Section 16 Planning Application for Proposed Mixed-Use Development (Proposed Flat with Permitted Commercial Uses) with Minor Relaxation of Building Height Restriction at Lot 4354 in D.D. 124, Kiu Tau Wai, Yuen Long (Application No. A/HSK/617)

Response to Departmental Comments

FIGURE 3.1

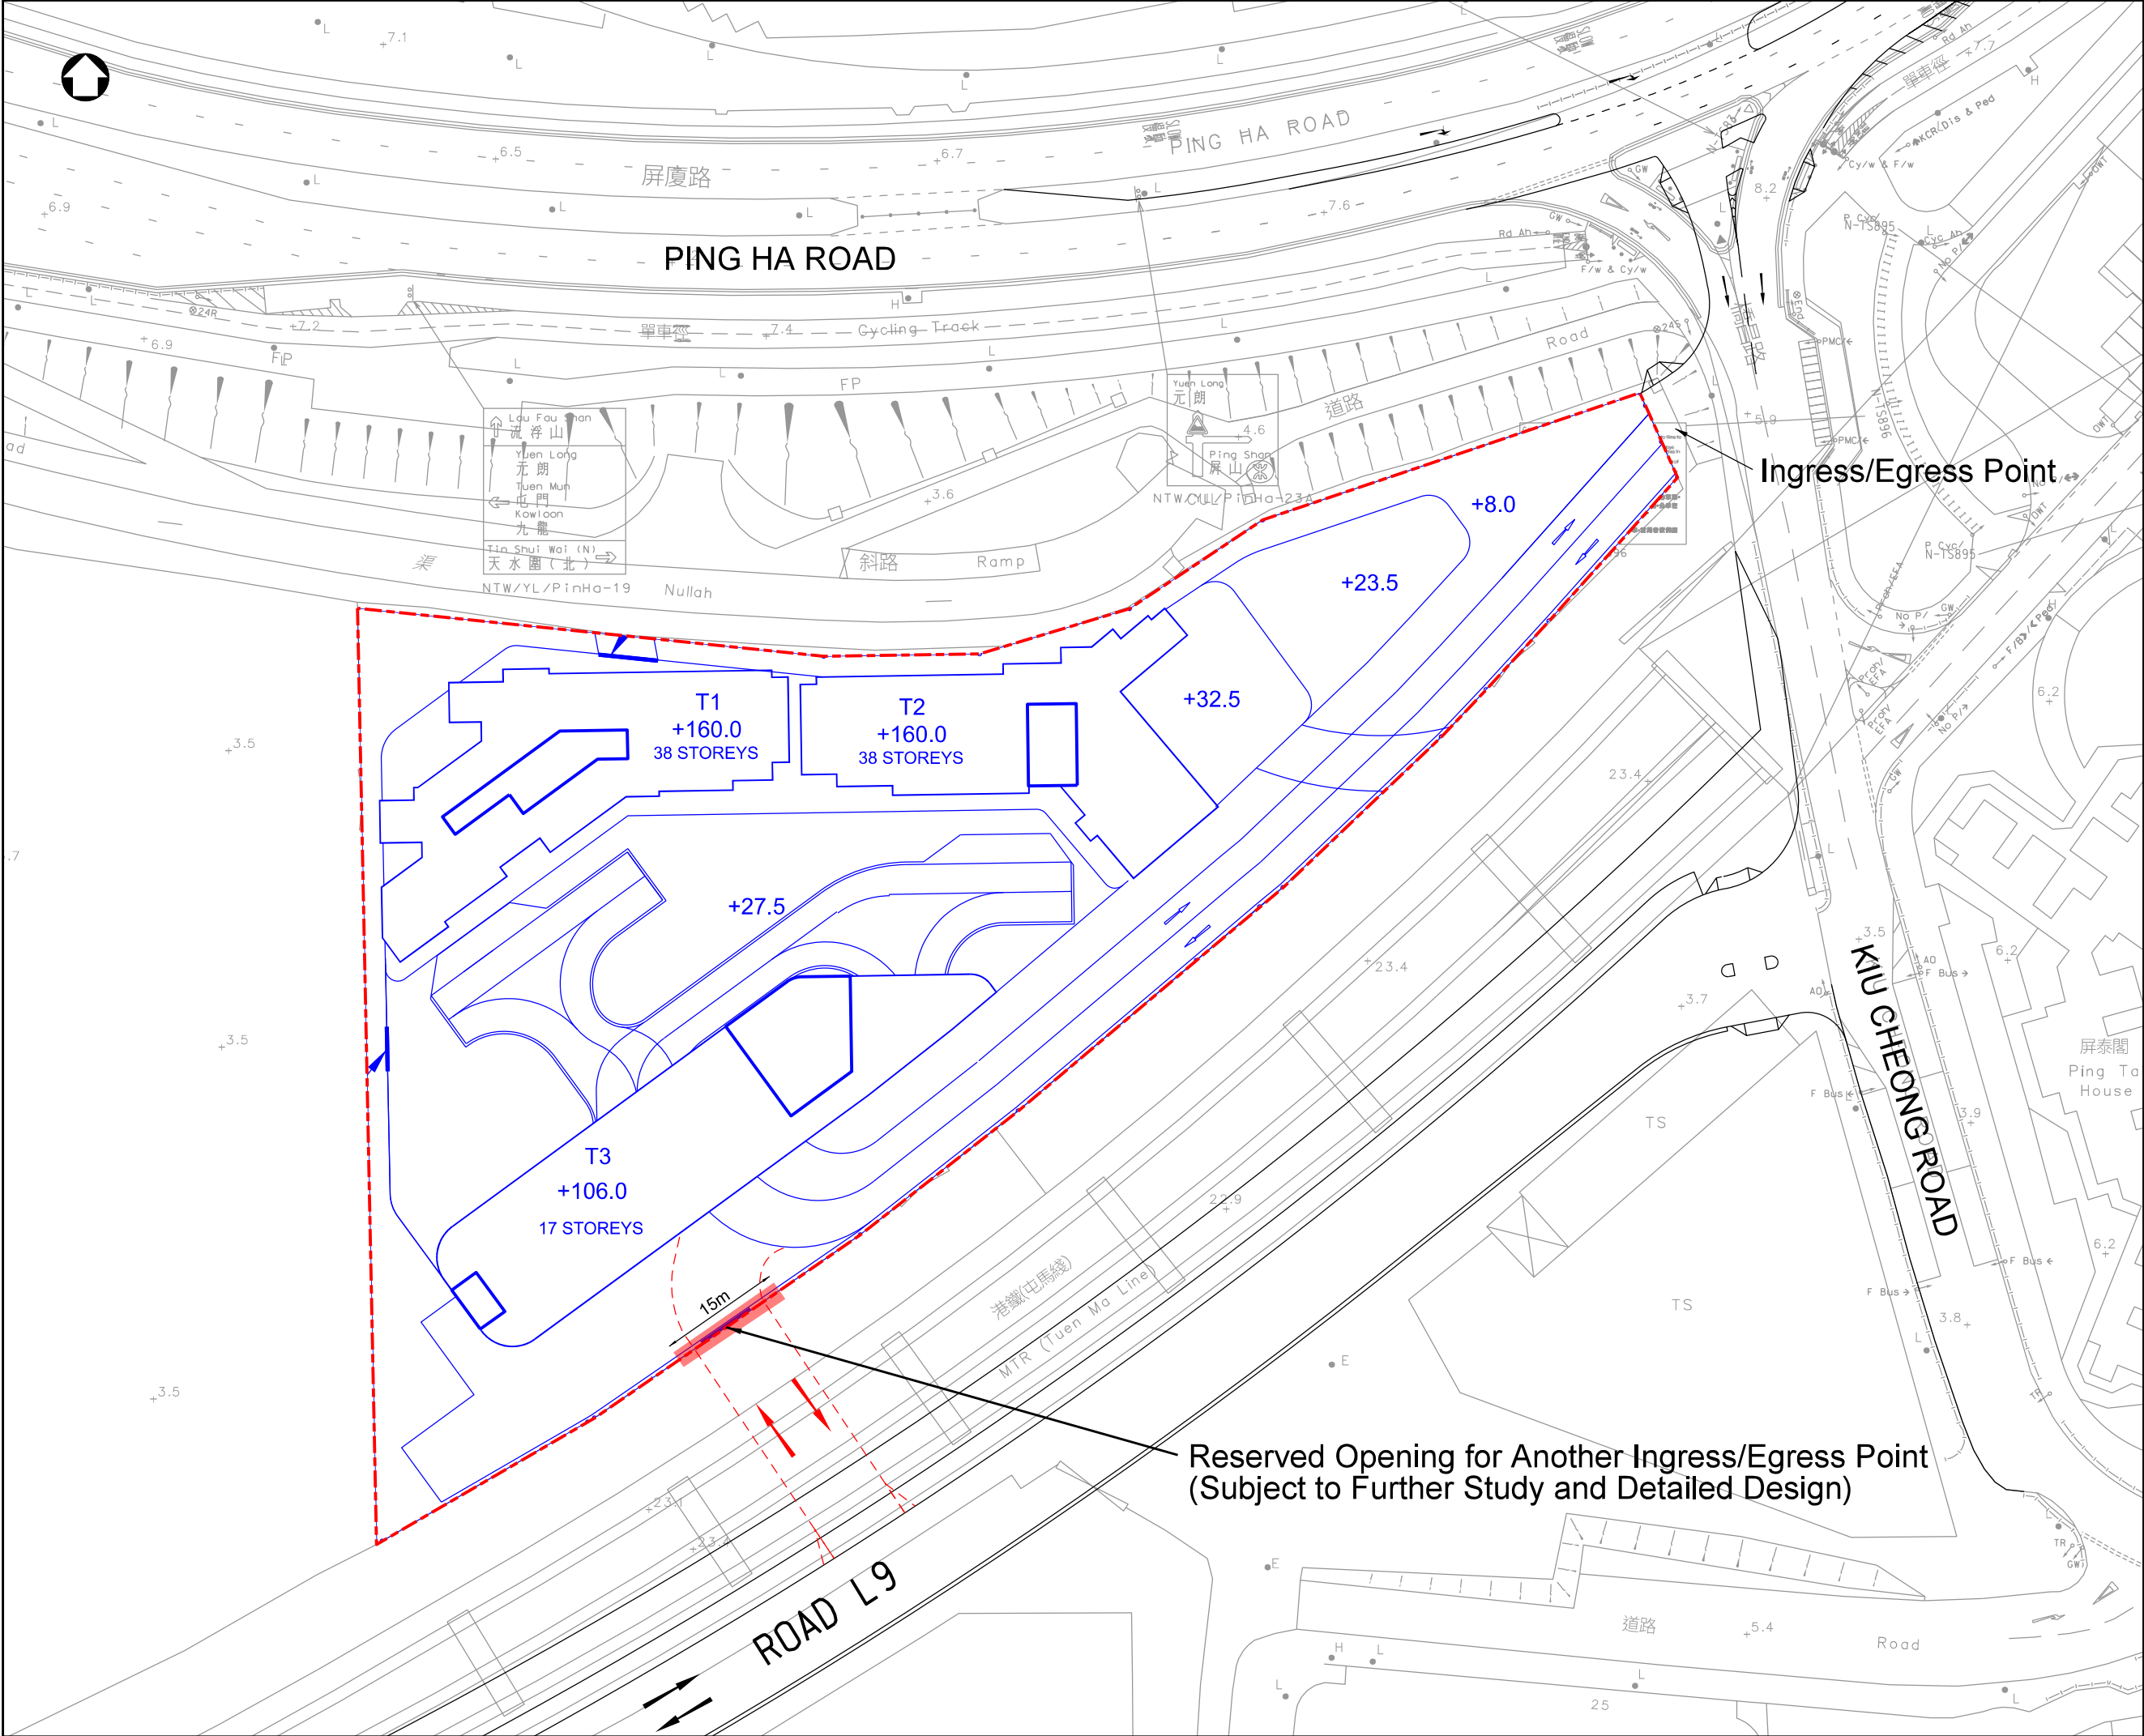
8.5	Figure 3.1: the proposed vehicular access point of the development is inconsistent with that shown in Figure 3.2. Please clarify.	Noted. Figure 3.1 of the TIA replacement pages under Attachment 3 has been revised accordingly.

FIGURE 3.2

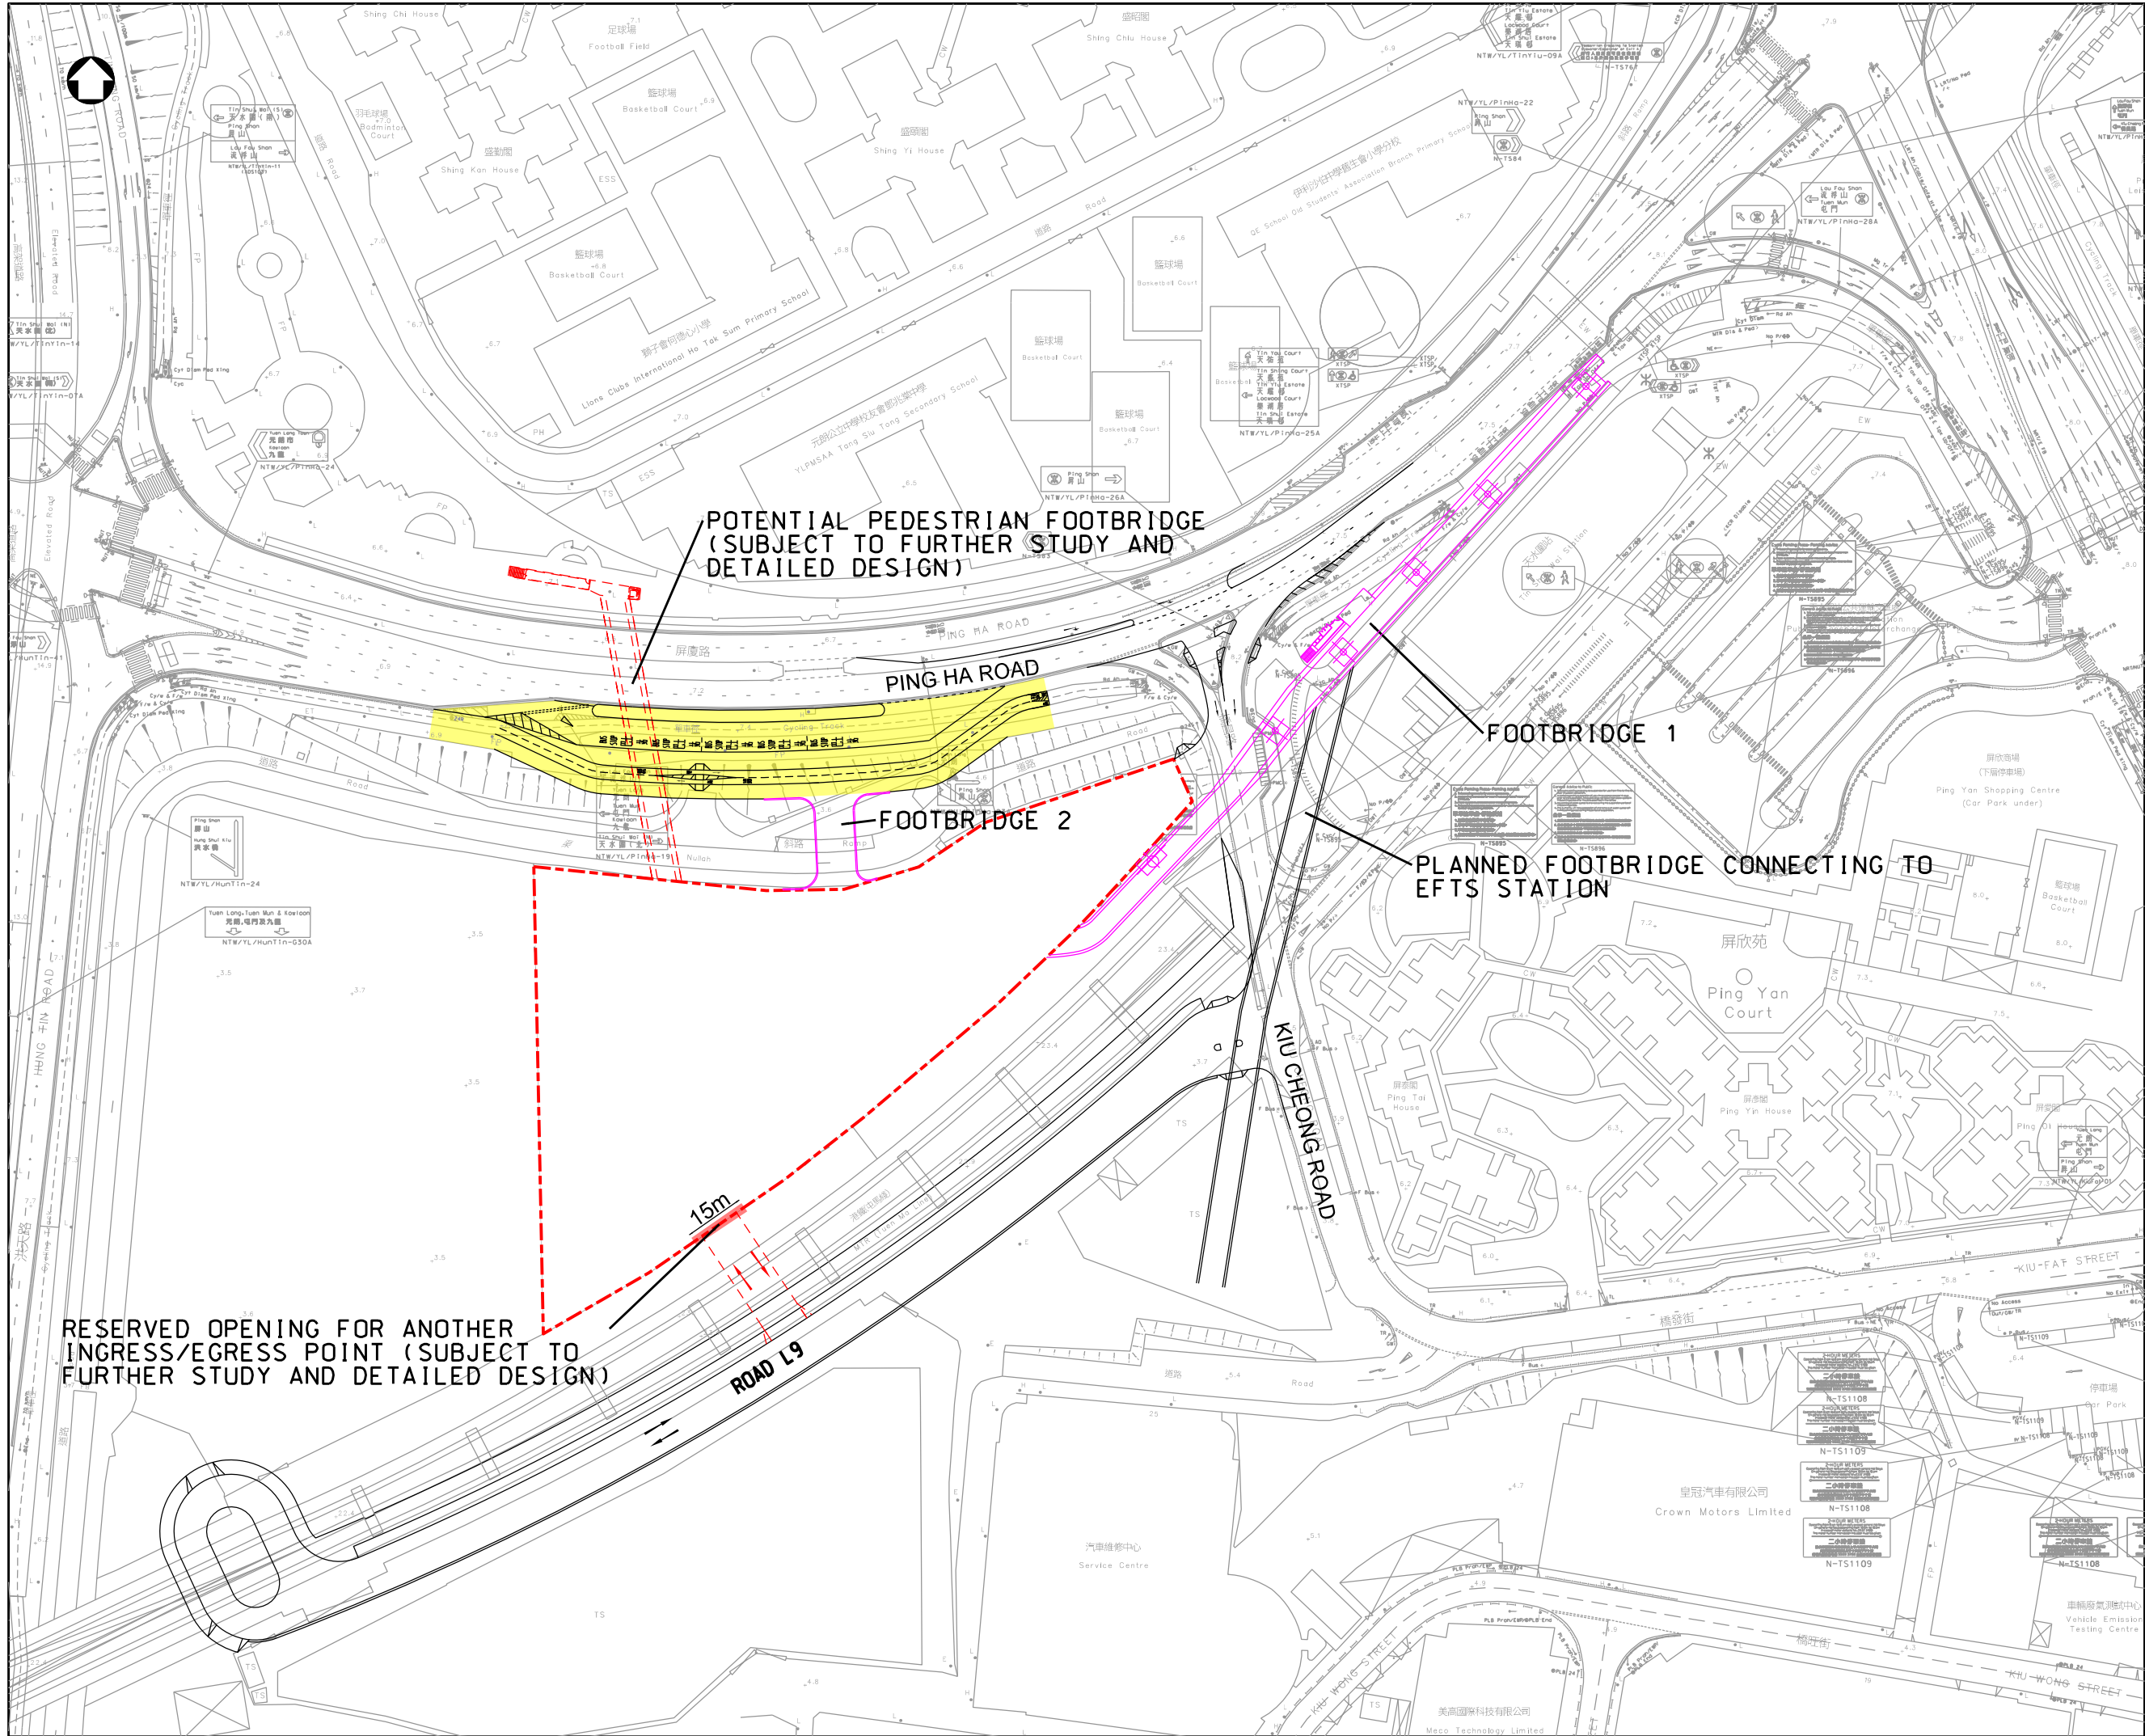
8.6	Figure 3.2: for the access road connecting to the proposed Road L9. The road width shall be widened to facilitate both the access of residential parking spaces and queuing of visitors' parking spaces.	Noted. The road width has been widened as shown in Figure 3.2 of the TIA replacement pages under Attachment 3 accordingly to facilitate both the access of residential parking spaces and queuing of visitors' parking spaces.

8.7	Figure 3.2: please indicate the proposed column location for the proposed bridge structures.	Noted. The proposed column location has been indicated in Figure 3.2 of the TIA replacement pages under Attachment 3 accordingly.

Figure: 2.2	RAMBOLL
Title: Propose Road Traffic Noise Mitigation Measures	Drawn by: KK
Project: Section 16 Planning Application For Proposed Comprehensive Development At Lot No 4354 In Dd 124, Kiu Tau Wai, Ping Shan, Yuen Long	Checked by: TC
	Rev.: 1.2 Date: Aug 2026

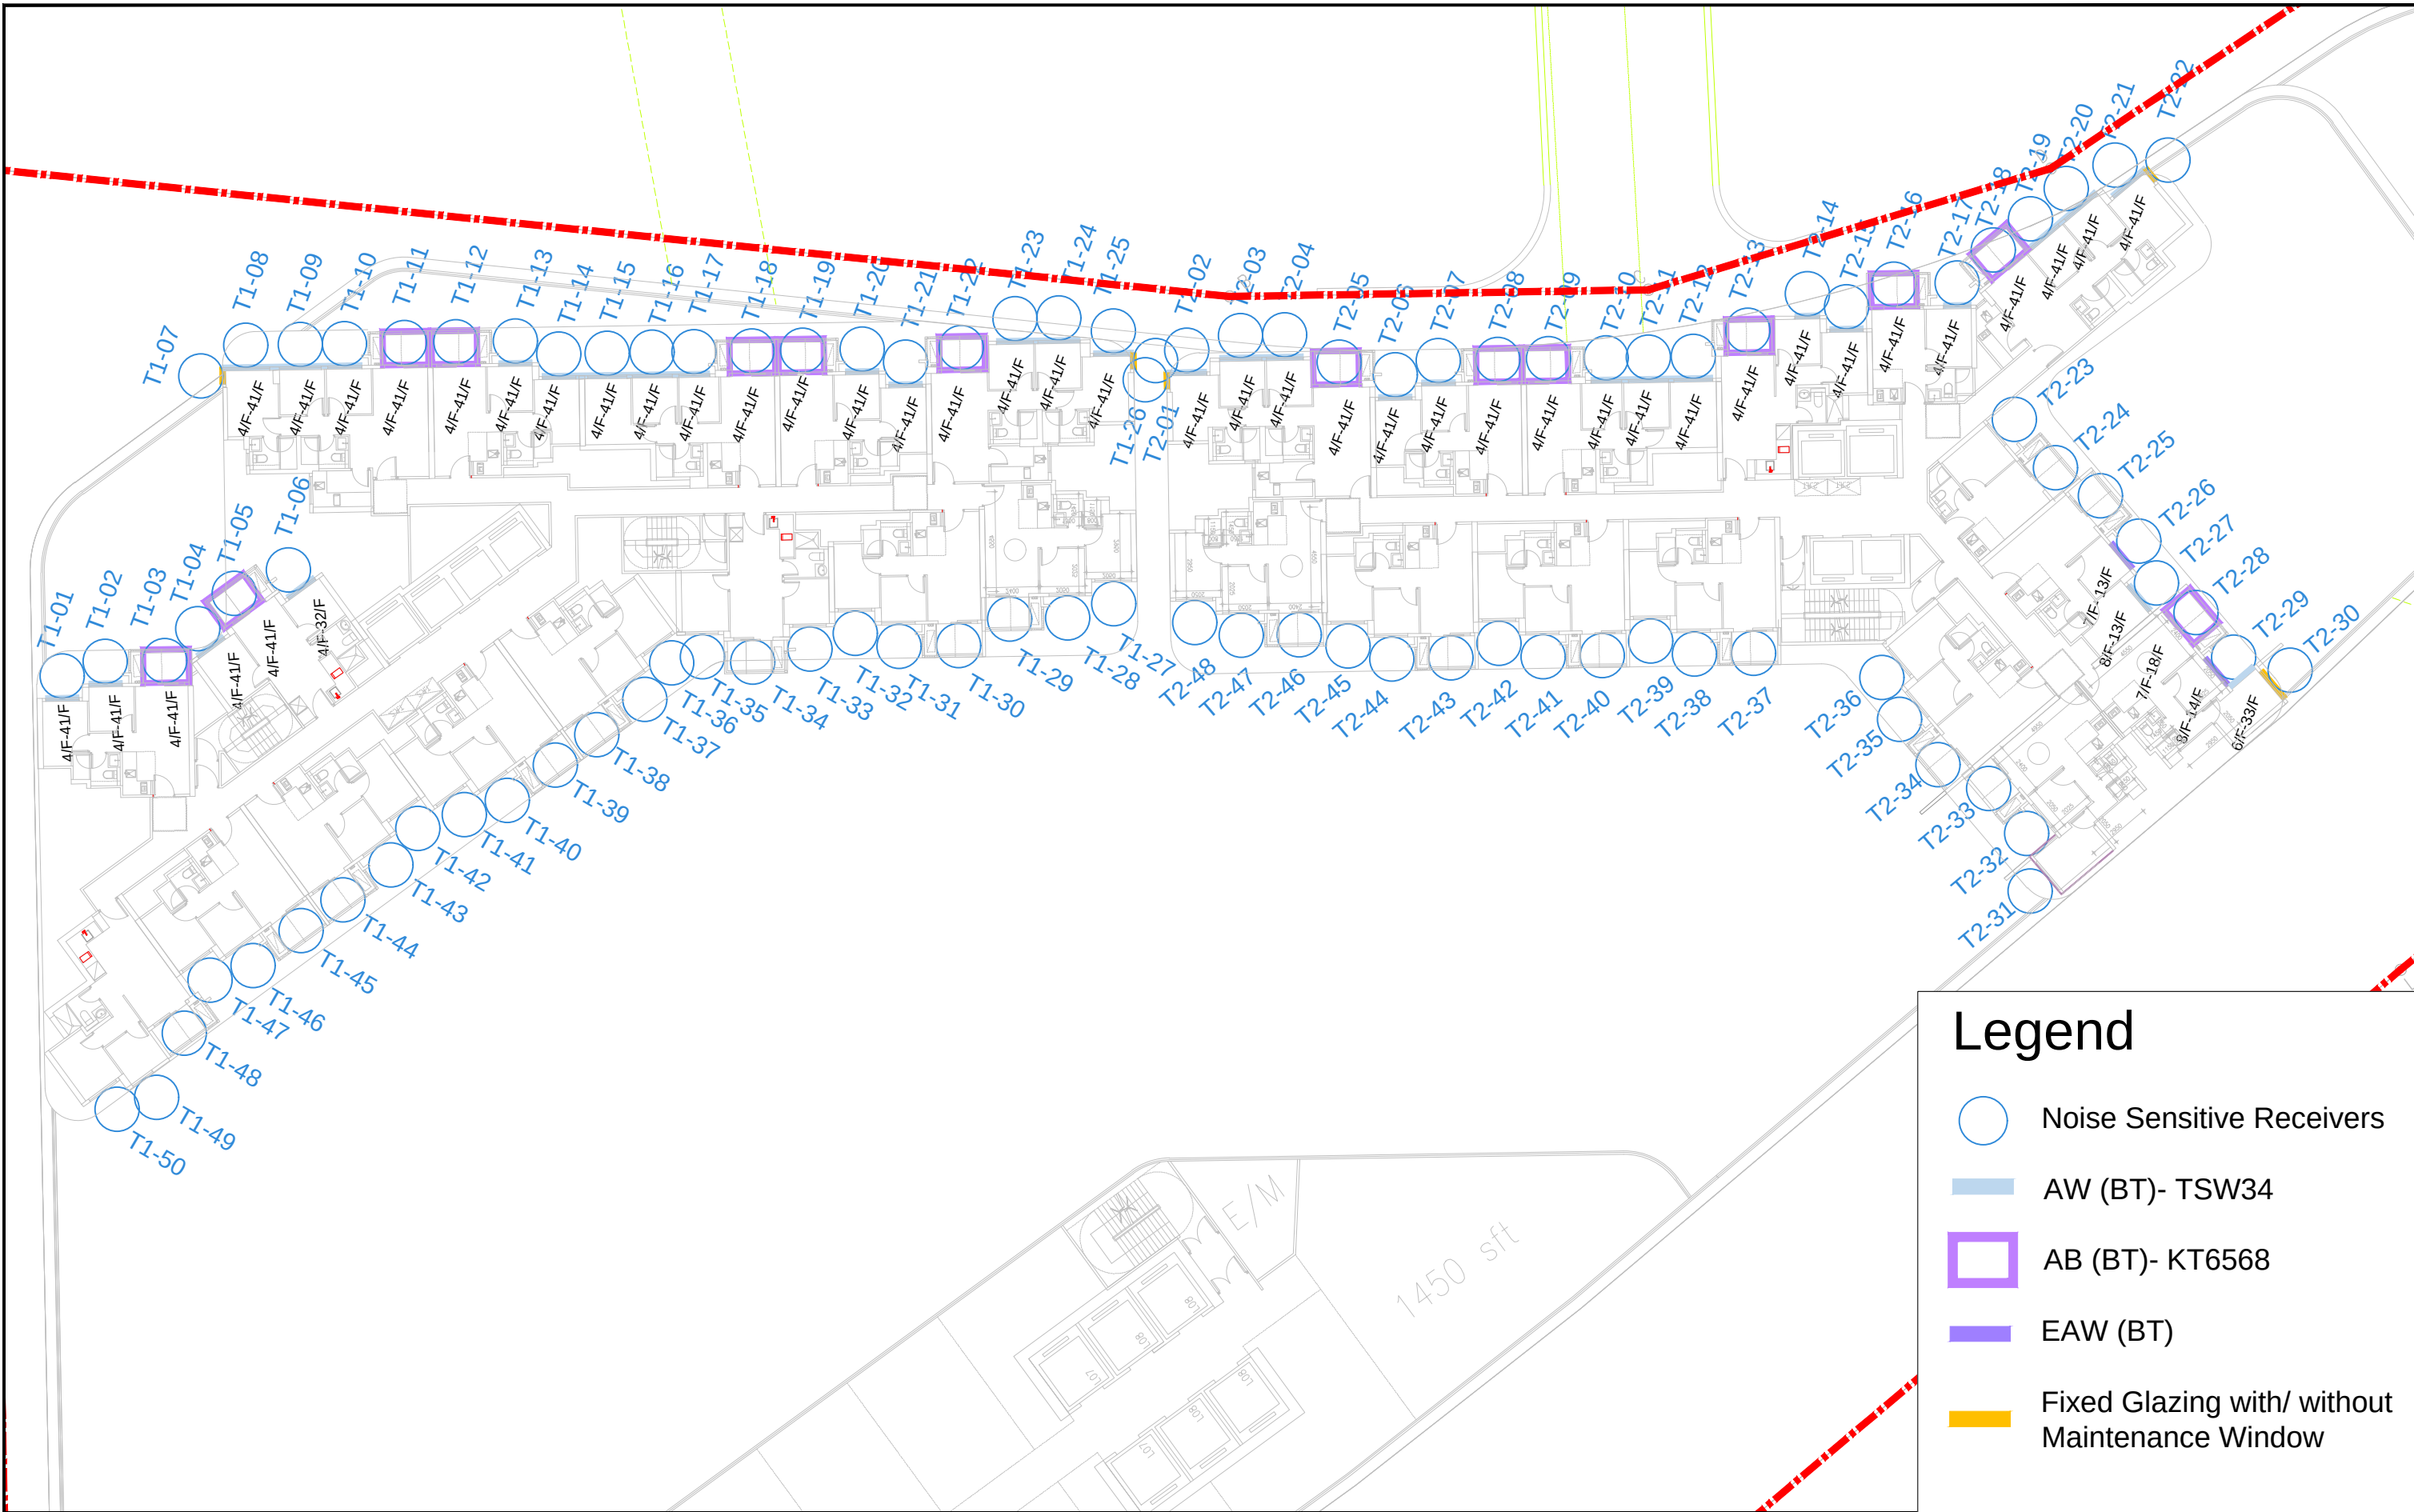
4.30	Figure 2.2 & Figure 3.2 – Different mitigation measures for same NAP (e.g. T2-30) are spotted under the traffic noise impact assessment and railway noise impact assessment respectively. Please review and revise to ensure the consistency.	Noted. Section 2.8.16, Table 2.2, Figure 2.2, Appendix 2.4, Appendix 2.5 and Appendix 2.6 of the EA replacement pages under Attachment 4 have been revised accordingly.
